# Access Compliance Report

## Public Rights-of-Way

| Intersection ID: 28011 | Main Street: CHANCELOT_LN | Cross Street: LEGACY_CR | Location: NE           |
| ADA ID: F58F7026C67F   | Ramp Type: Perp           | Initial Pass/Fail: Pass | Overall Compliance: No |

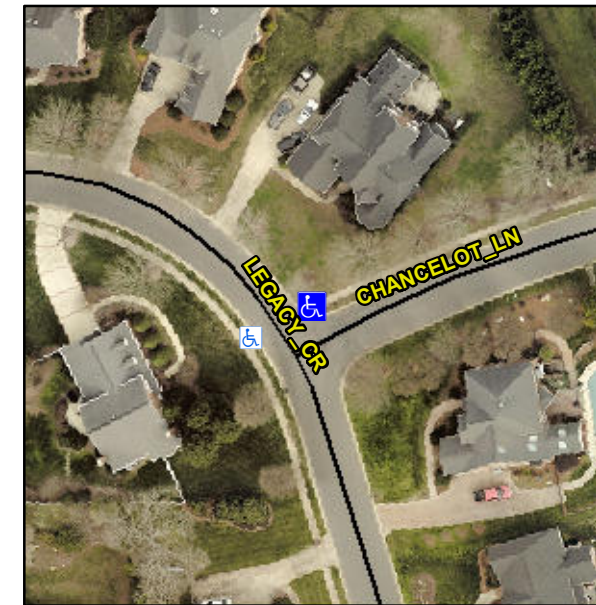
**Not Found, R304.2.1, R304.2.2-Perp,  
R304.3.2-Para, R304.5.3**

| Compliance | Description           | Data   | Compliance | Description                 | Data |
|------------|-----------------------|--------|------------|-----------------------------|------|
| No         | Landing Length (in)   | N/A    | Yes        | DWS Provided?               | Yes  |
| Yes        | Gutter Lip Ht (in)    | 0.0    | No         | Gutter X Slope (%)          | 2.3  |

**Remove & Replace Entire Ramp.  
Remove & Replace Gutter.**
